Discretionary Review Abbreviated Analysis

Date: December 11, 2014
Case No.: **2014-000335DRP**
Project Address: **2744 STEINER STREET**
Permit Application: 2014.2.14.8525
Zoning: RH-1 [Residential House, One-Family]
40-X Height and Bulk District
Block/Lot: 0563/015
Project Sponsor: Illeana Figueroa-Mills
Sutro Architects
915 Battery Street
San Francisco, CA 94111
Staff Contact: Sharon Lai – (415) 575-9087
sharon.w.lai@sfgov.org
Recommendation: **Do not take DR and approve as proposed**

The project proposes to construct horizontal expansions at three levels, including a two-story horizontal rear extension, the addition of three dormers, the replacement of the front bay projection, and regularization of the southwest corner at the third floor of the two-and-a-half story over garage single-family house. The proposal will add approximately 660 square feet of habitable space. The project also includes remodeling of the interior and other exterior modifications including new windows and doors.

*SPONSOR'S PROPOSED REVISION
(2nd Floor)*

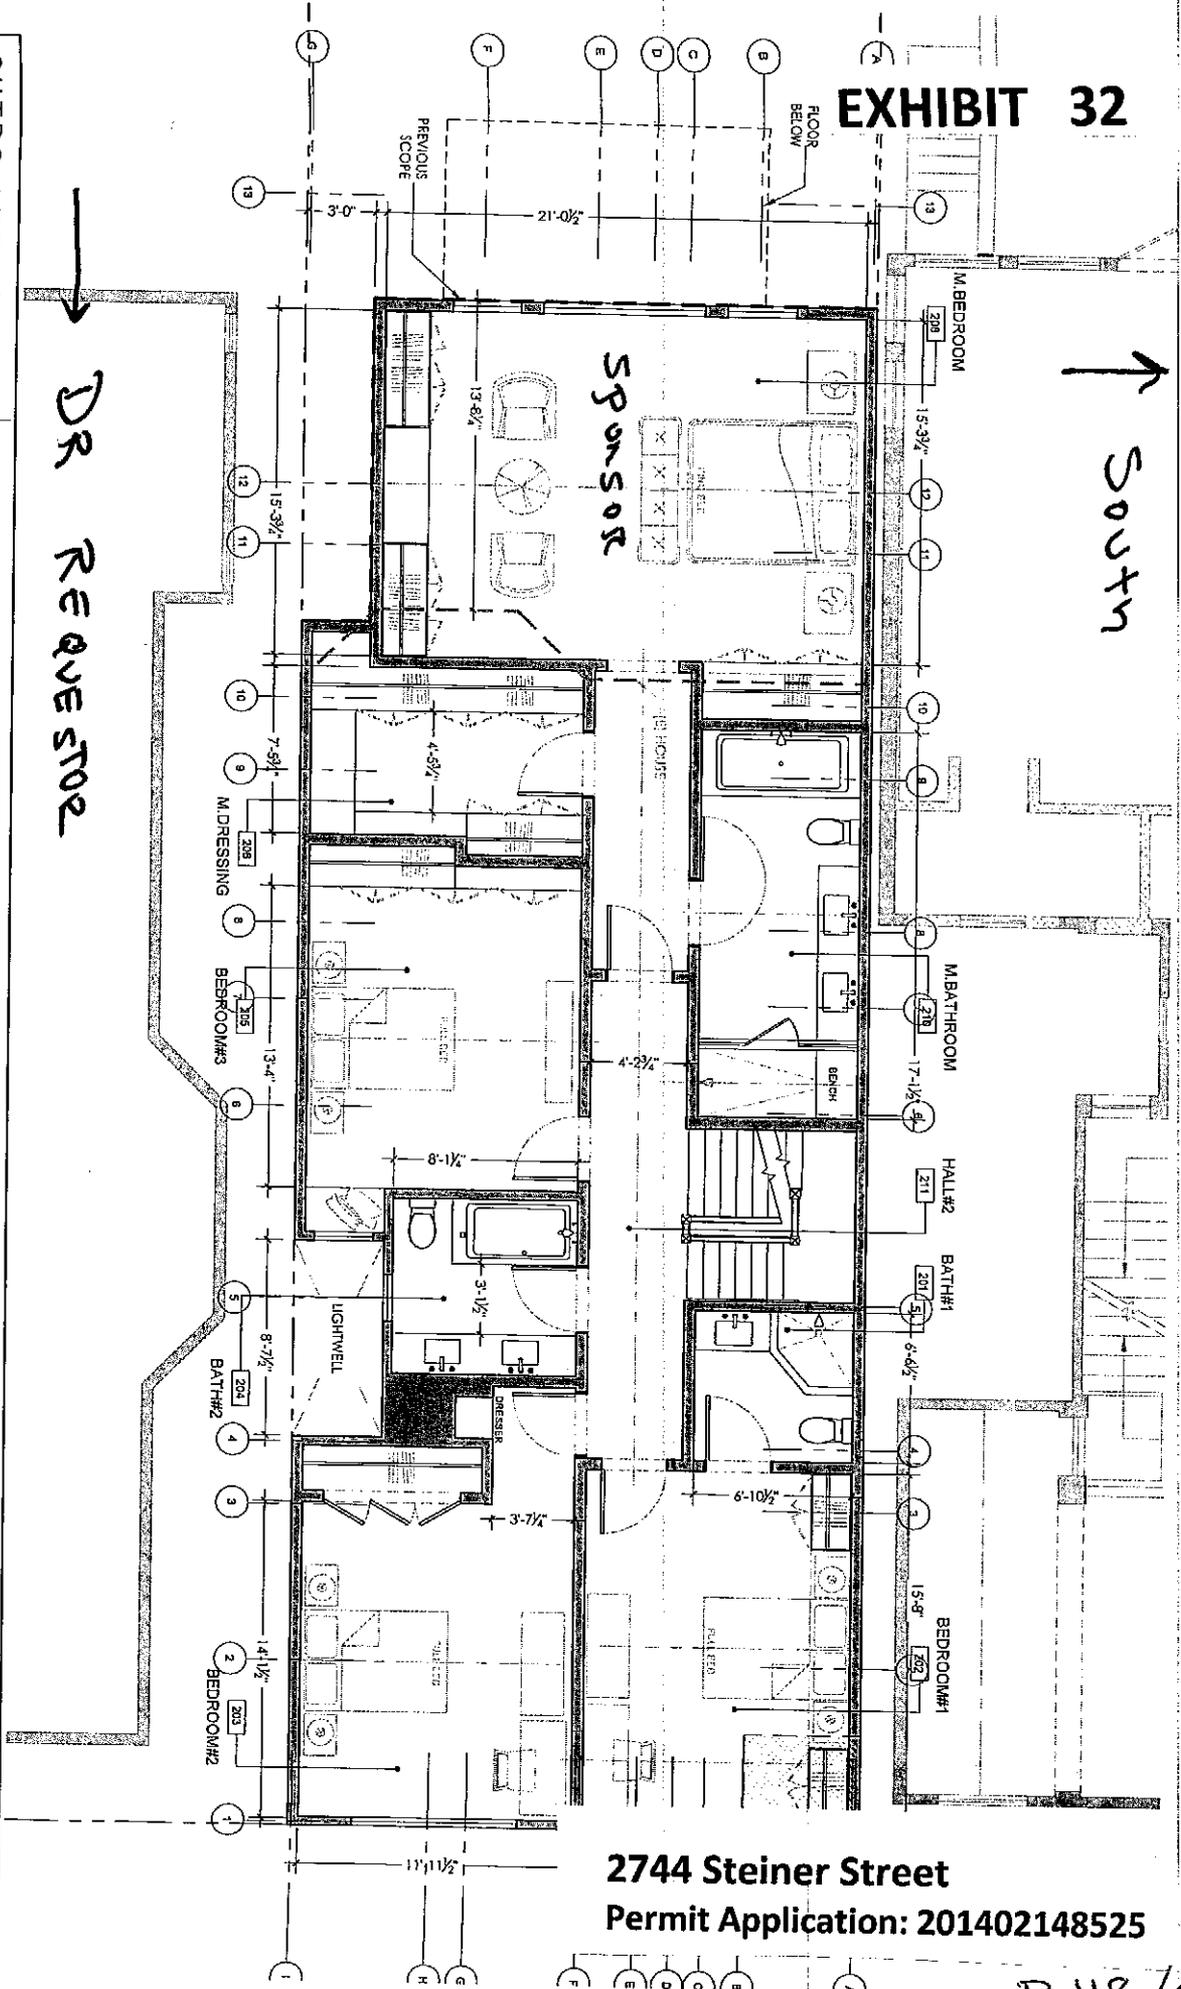
12. On June 13th, DR Requestor sent an e-mail to sponsor addressing some of the issues with the revised plan and indicating that their revised plan is far worse than the original plan. Although they are proposing a six foot set-back on the first floor, the second floor set back remains at three feet which is an overhang on the first floor. This overhang does not address the issue of LIGHT & AIR. **In addition, the sponsor proposed to build an outdoor kitchen on the six foot set-back immediately adjacent to the Talebi’s deck. Exhibit 31, Page 47 & Exhibit 32, Page 48.** In other words, by placing the outdoor kitchen next to the Talebi’s Deck and family room, the sponsor made sure that the revision is far worse than the original plan submitted to the Planning Department.

EXHIBIT 3: Consistent Rearyard line

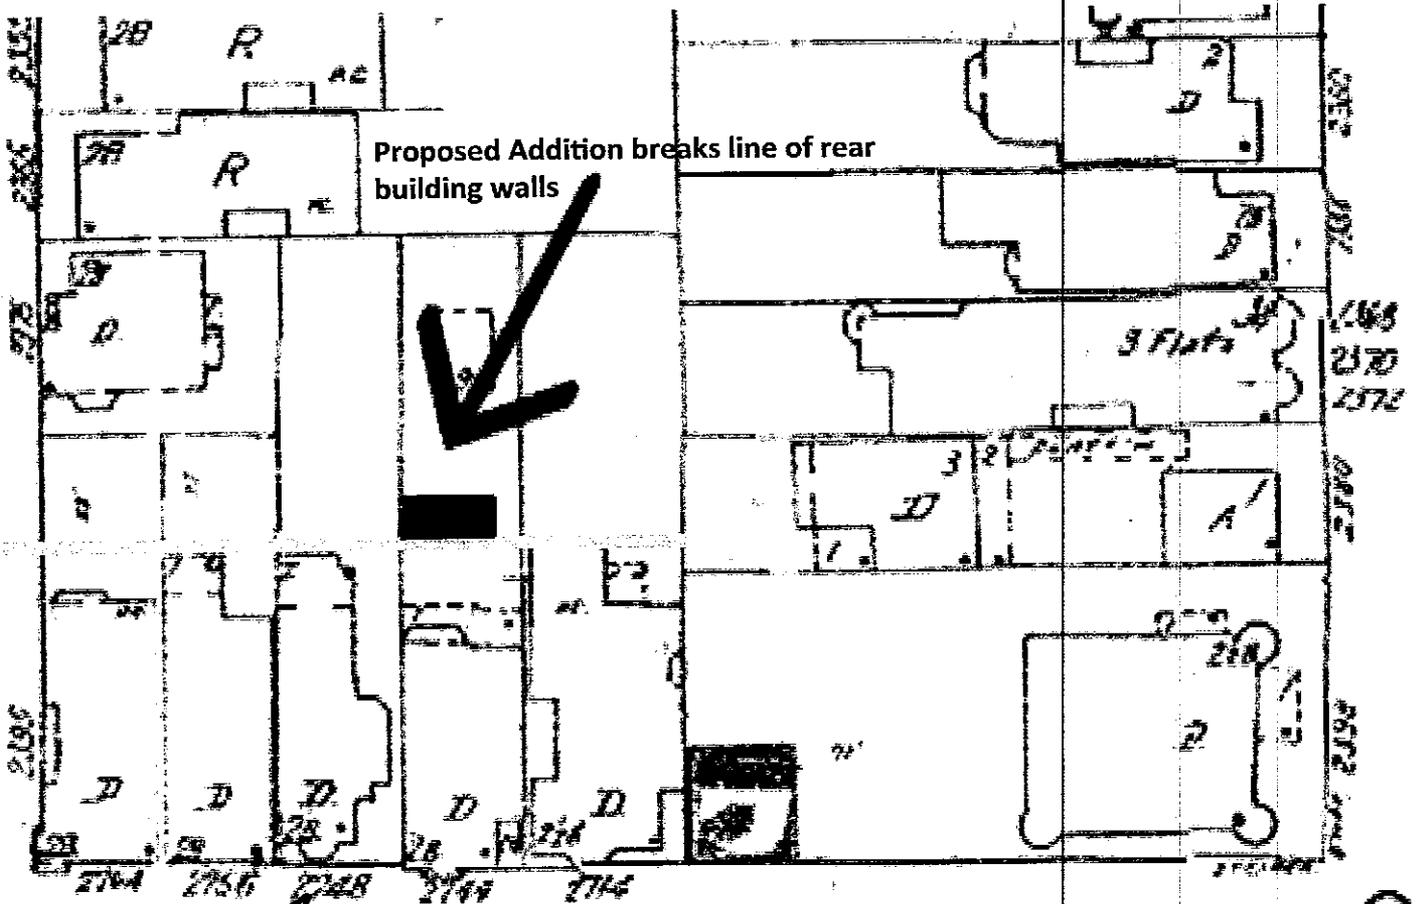
REQUESTER'S ANSWER: For over a century a consistent line formed by the rearmost walls of every building on this block of Steiner defined the west boundary of the block's mid-block open space. See EXHIBIT 3: Sanborn Map. The proposed first floor rear addition will break this line and therefore impact the contiguous nature of the mid-block open space.
